**Subject: 421 Warren Avenue
Preliminary Level III Site Plan Application
Response to Peer Review Comments**

**Subject: 421 Warren Avenue
Final Site Plan Application/Delegated Review Stormwater
Comment Response #1 Supplemental information**

WB-67 AASHTO 2011 (US)

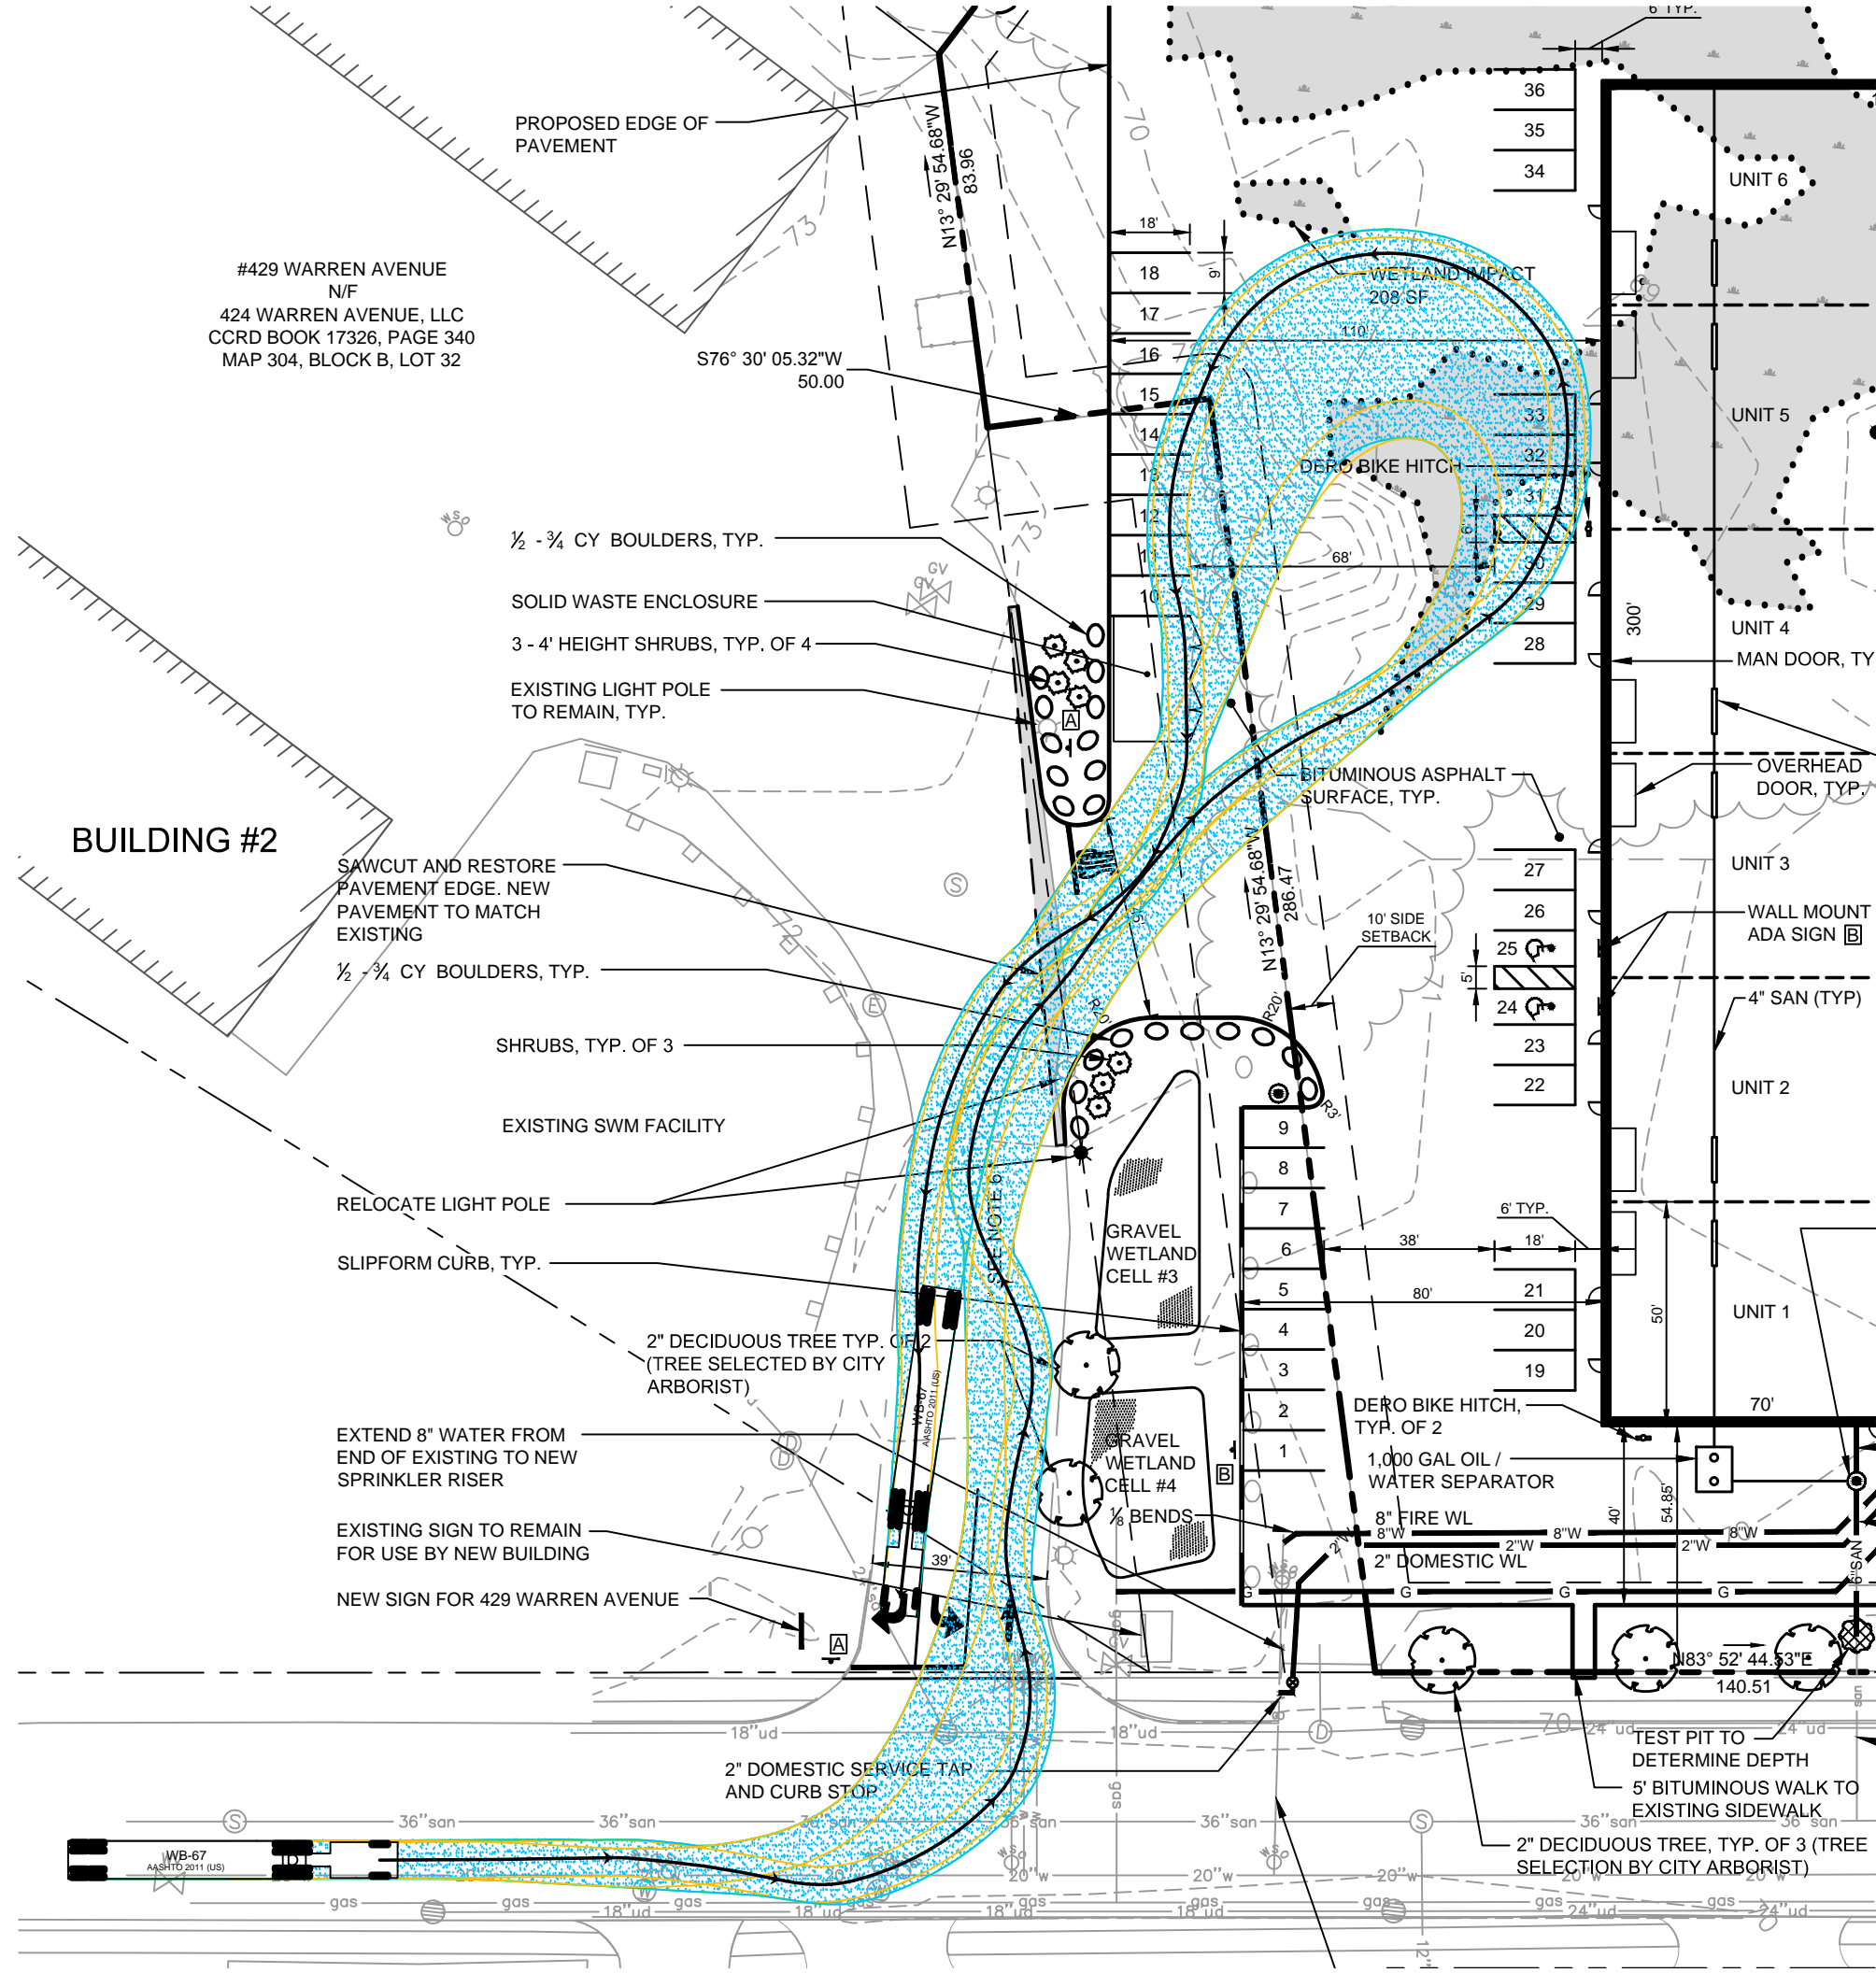
The aisle widths in the internal parking/circulation area do not meet City standards and a waiver will be required. The applicant shall provide an Auto-Turn analysis documenting the need for the expanded pavement areas.

See the accompanying Auto-Turn figure depicting the movement of a WB-67 vehicle into/out of the proposed yard area. The applicant is requesting a waiver of the parking area dimensional standards.
